**SUPPLEMENT 1
TO
BORIC ACID CONCENTRATION
REDUCTION EFFORT**

CEN-353(F)

**SAINT LUCIE NUCLEAR POWER PLANT
UNIT 1**

**PREPARED FOR
FLORIDA POWER & LIGHT COMPANY**

FIGURE 3-1 ST. LUCIE 1 MIN BMT VOLUME
vs STORED BMT CONCENTRATION

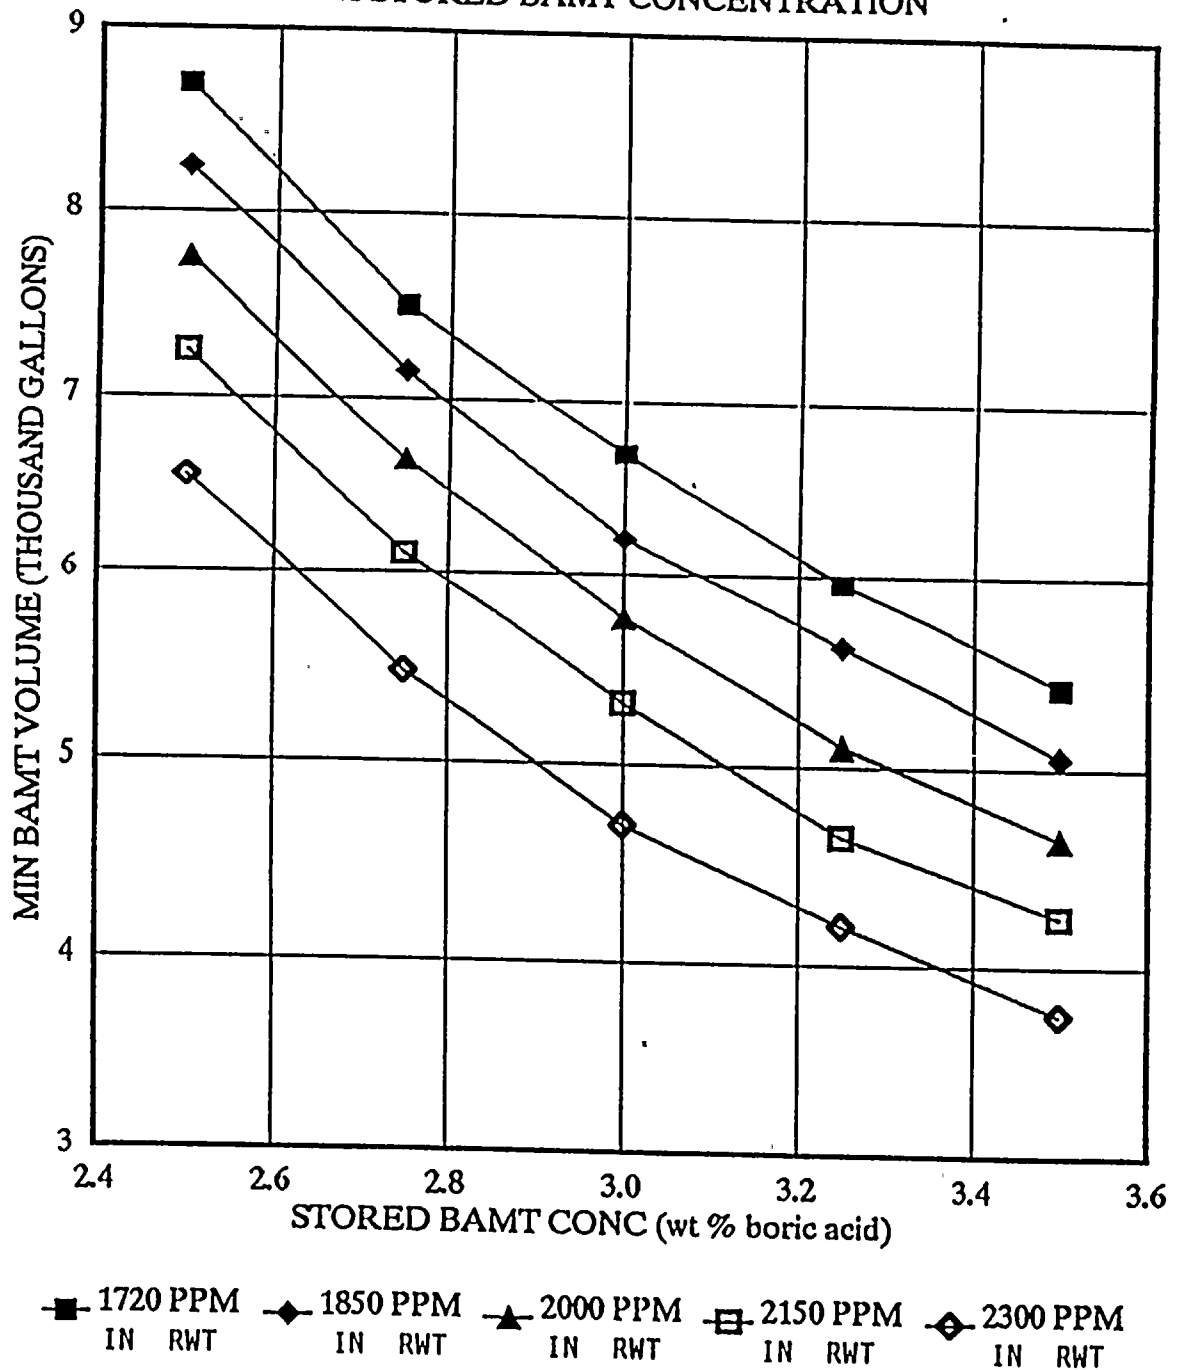
Manual handwheel operation of motor operated valve V2504 is acceptable for St. Lucie Unit 1 cooldown scenarios. Revising this assumption will make the St. Lucie Unit 1 analysis agree with the Unit 2 analysis for this assumption. With manual operation of V2504, adjustment of the boration volume to include the volume for depressurization will no longer be required.

During the St. Lucie Unit 2 BACR analysis, 500 gallons were added to the BAMT boration volumes for conservatism. To be consistent with Unit 2, 500 gallons will be added to the St. Lucie Unit 1 BAMT boration volumes to define the revised Technical Specification BAMT Storage volume requirements. The boration volumes will be rounded up to the next 50 gallons, and 500 gallons will be added for conservatism. The resulting Required BAMT Storage Volumes are contained in Table 3-2 and are plotted in Figure 3-1. Figure 3-1 provides the revised storage requirements to replace Figure 2-6 on page 82 of the main report.

BAMT at wt %	RWT at 1720 ppm	RWT at 1850 ppm	RWT at 2000 ppm	RWT at 2150 ppm	RWST at 2300 ppm
2.50	8700	8250	7750	7250	6550
2.75	7500	7150	6650	6100	5450
3.00	6700	6200	5750	5300	4700
3.25	5950	5600	5100	4650	4200
3.50	5400	5050	4650	4250	3750

FIGURE 3.1-1 ST. LUCIE 1 MIN BAMT VOLUME

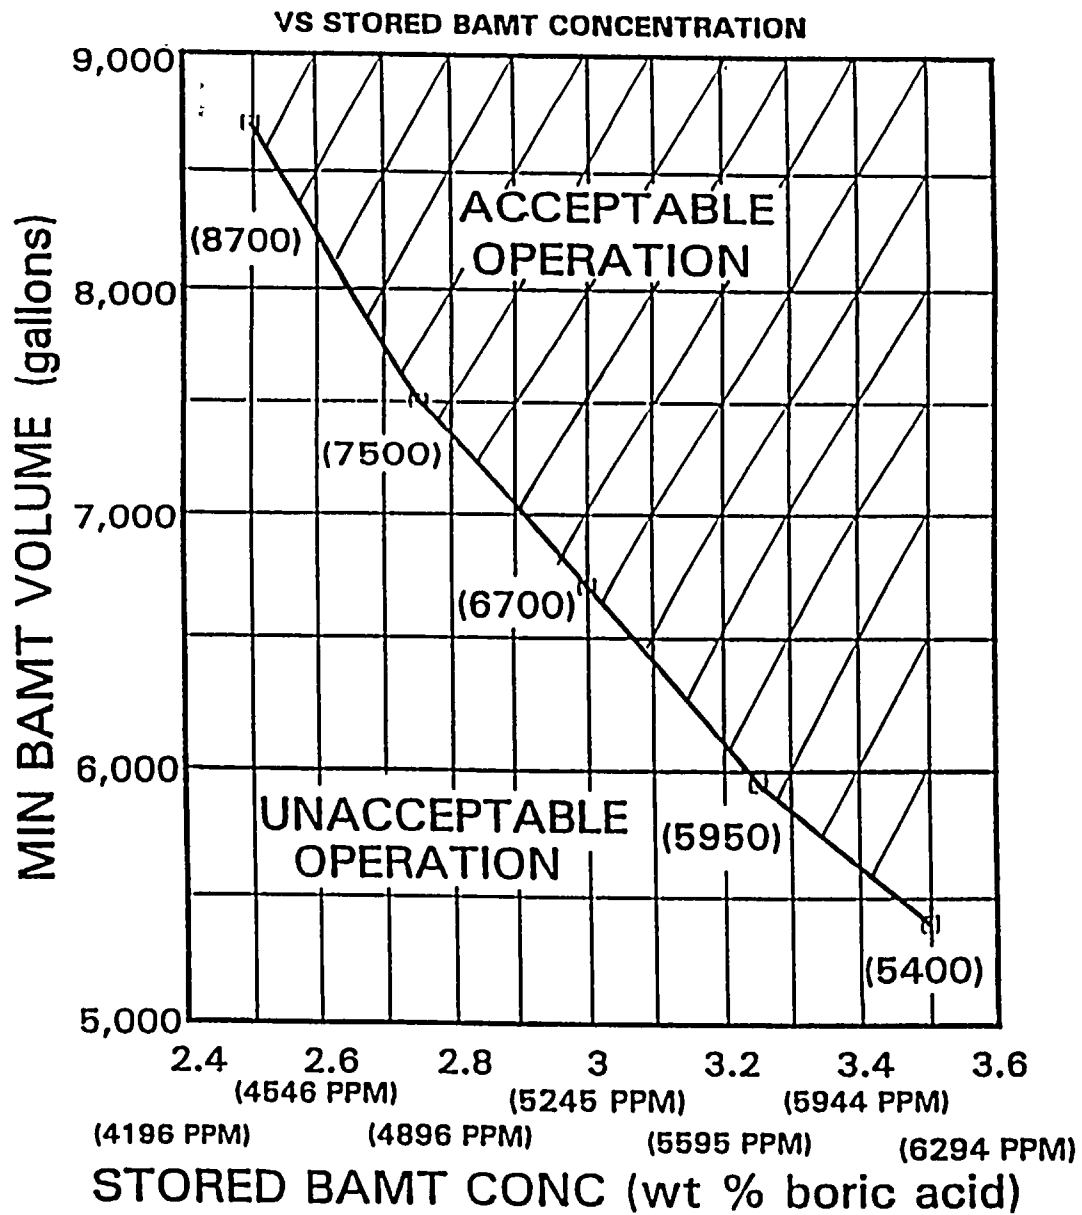
FP&L currently requests that only one curve be presented in the Required BAMT Volume curve, Technical Specification Figure 3.1-1, rather than the family of curves for various RWT concentrations. FP&L requests that only the curve for the RWT at 1720 ppm be provided. The new Technical Specification Figure 3.1-1 is contained in Appendix A.

- a. Boric Acid Makeup Tank 1A in accordance with Figure 3.1-1, ~~and in the range of 3.2 to 3.5 weight percent boric acid (5595 to 6119 ppm boron).~~
- b. Boric Acid Makeup Tank 1B in accordance with Figure 3.1-1, ~~and in the range of 3.2 to 3.5 weight percent boric acid (5595 to 6119 ppm boron).~~
- c. Boric Acid Makeup Tanks 1A and 1B with a minimum combined contained borated water volume in accordance with Figure 3.1-1.
- d. The refueling water tank with:
 1. A minimum contained volume of 401,800 gallons of water,
 2. A minimum boron concentration of 1720 ppm,
 3. A maximum solution temperature of 100°F,
 4. A minimum solution temperature of 55°F when in MODES 1 and 2, and
 5. A minimum solution temperature of 40°F when in MODES 3 and 4.
